ND-2013-0002
January 11, 2013

Subject: **PSEG Early Site Permit Application**
Docket No. 52-043
Response to Request for Additional Information, RAI No. 61, Vibratory
Ground Motion

Response to RAI No. 61

02.05.02-10, SRP Section: 02.05.02 – Vibratory Ground Motion

Table RAI-61-10-14

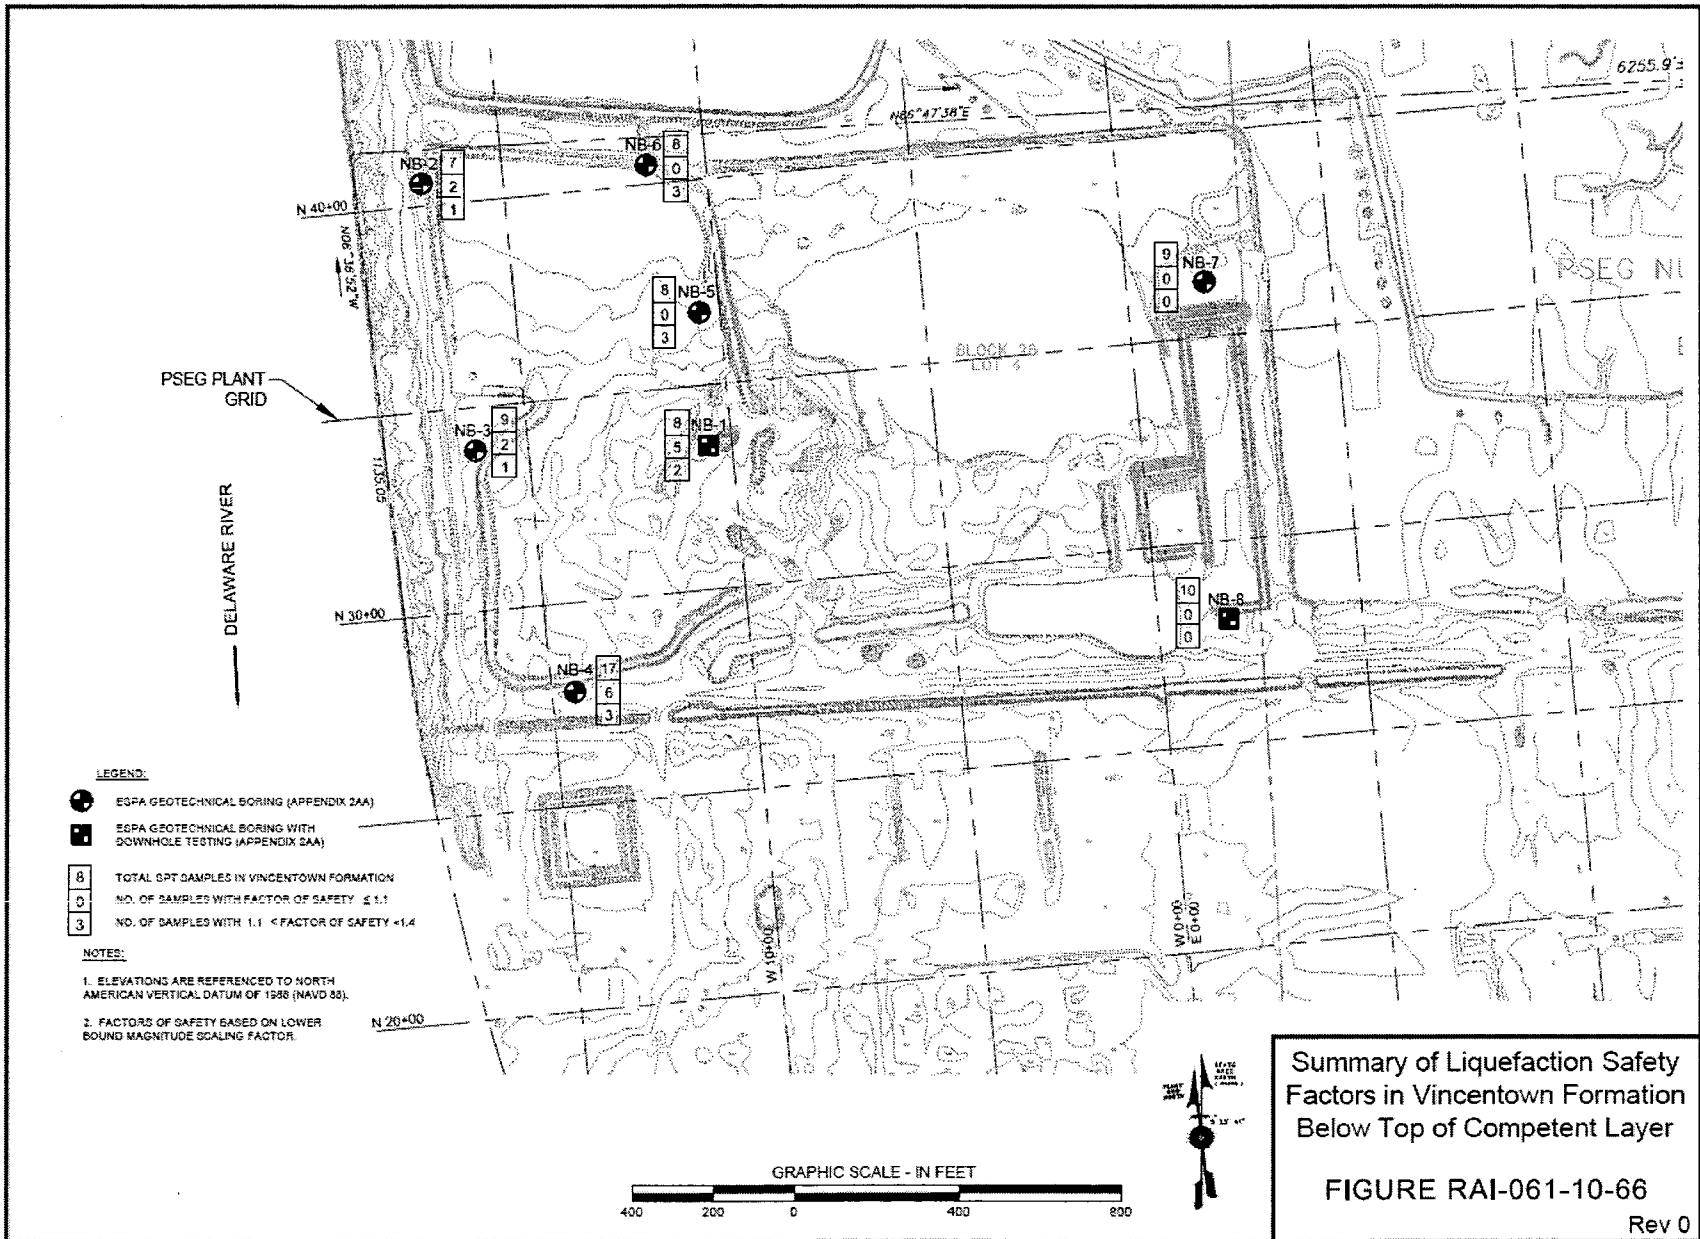
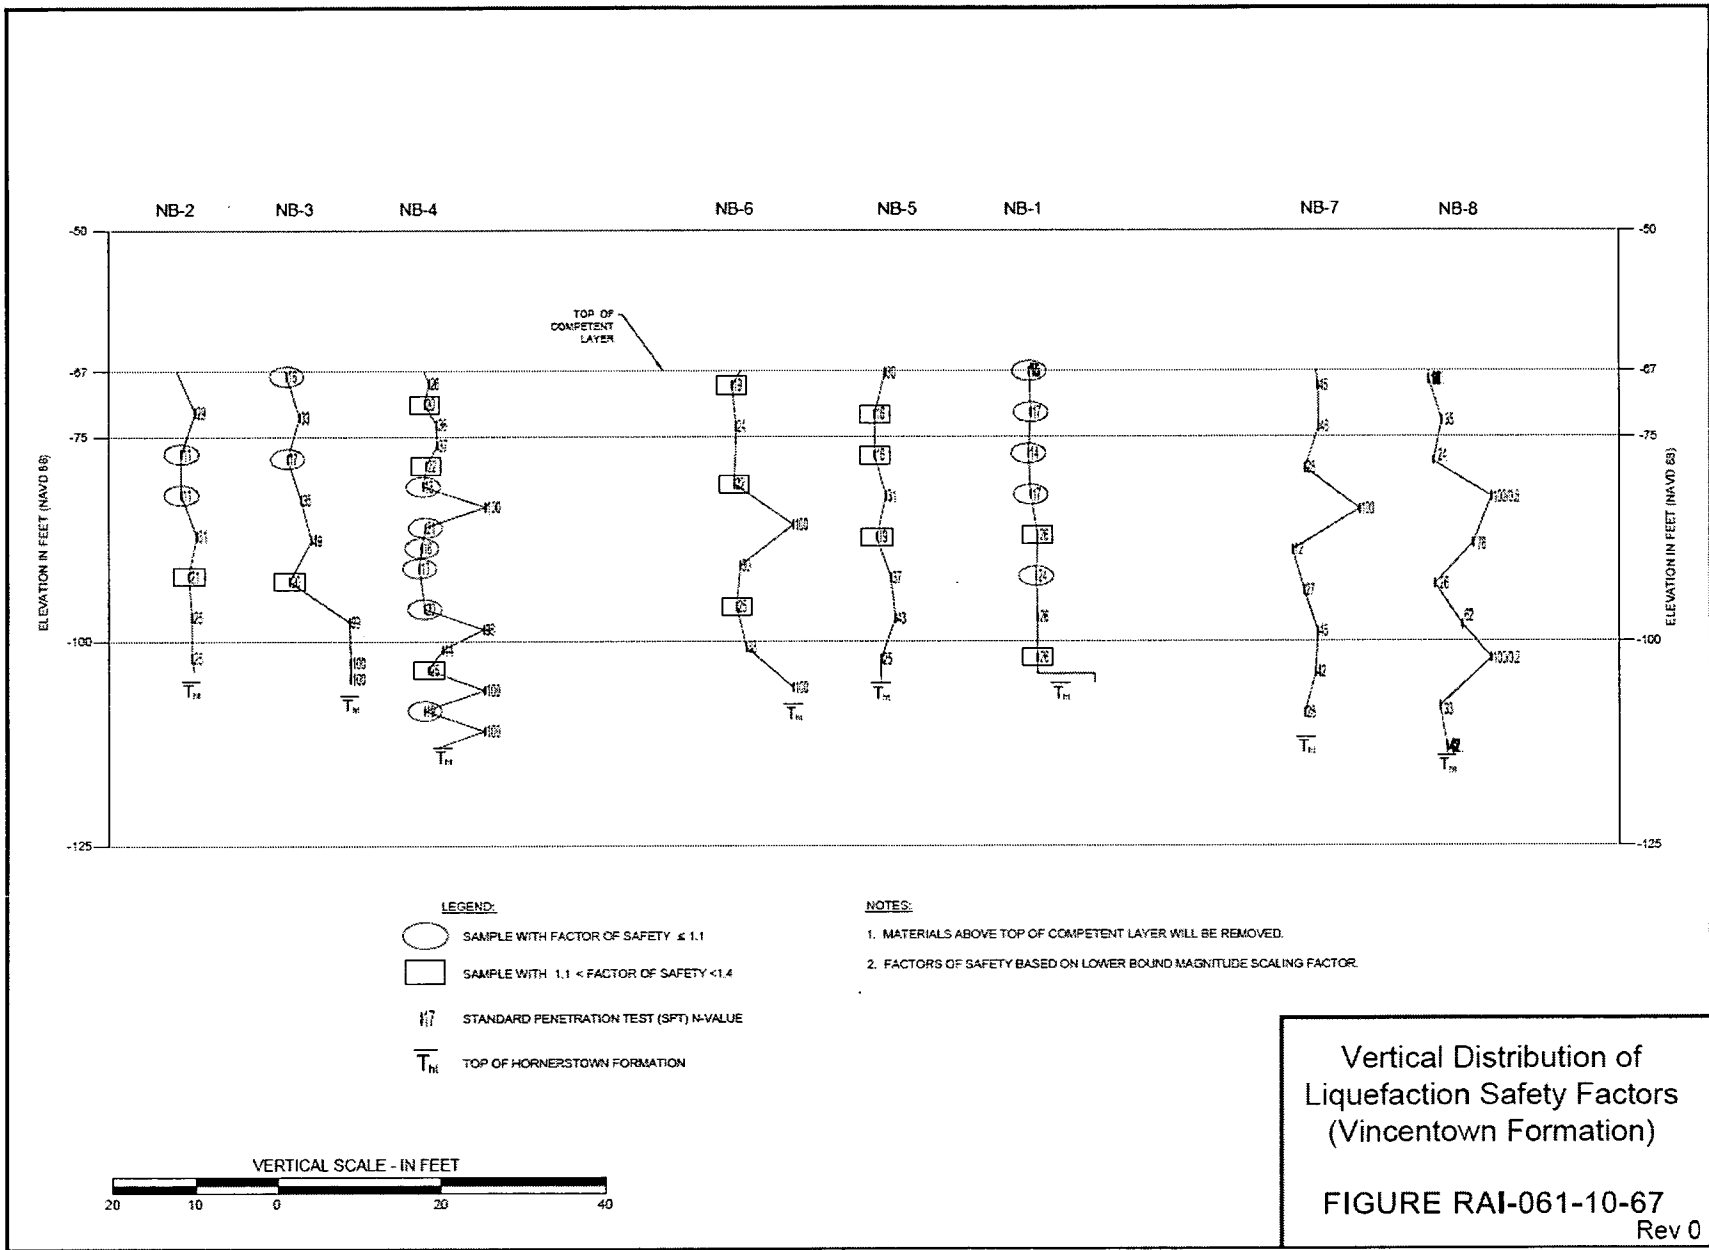
a) Evaluate the potential impacts of the newly released CEUS-SSC model, with potential local and regional refinements as identified in the CEUS-SSC model, on the seismic hazard curves and the site-specific ground motion response spectra (GMRS). For re-calculation of the PSHA, please follow either the cumulative absolute velocity (CAV) filter or minimum magnitude specifications outlined in Attachment 1 to Seismic Enclosure 1 of the March 12, 2012, letter "Request for information pursuant to title 10 of the Code of Federal Regulations 50.54(f) regarding recommendations 2.1, 2.3, and 9.3, of the near-term task force review of insights from the Fukushima Dai-ichi accident." (ML12053A340)

b) Modify the site-specific GMRS if you determine changes are necessary given the evaluation performed in part a) above.

Reference 6, the value of GMRS at 100 Hz using the CEUS-SSC (NUREG-2115) is 0.225g, which is greater than the value presented in existing Subsection 2.5.4.8.3 (0.18g). Calculation 360-RAI-061-10 examines the effect of the higher input acceleration on the calculated factors of safety against liquefaction (Reference RAI-61-10-13).

The results of the calculation, summarized in Table RAI-61-10-14, show an increase in the numbers of samples with factors of safety less than or equal to 1.1 from 3 to 17, and an increase in the numbers of samples with factors of safety greater than 1.1 but less than 1.4 from 9 to 15. The total number of samples reviewed is 257. Distribution of the samples with low factors of safety within the Vincentown Formation, the formation at and below the level of the competent layer, is illustrated on Figures RAI-61-10-66 and RAI-61-10-67. The SPT-based screening calculation results indicate the potentially liquefiable soils in the Vincentown Formation are isolated zones surrounded by denser materials, not a continuous layer.
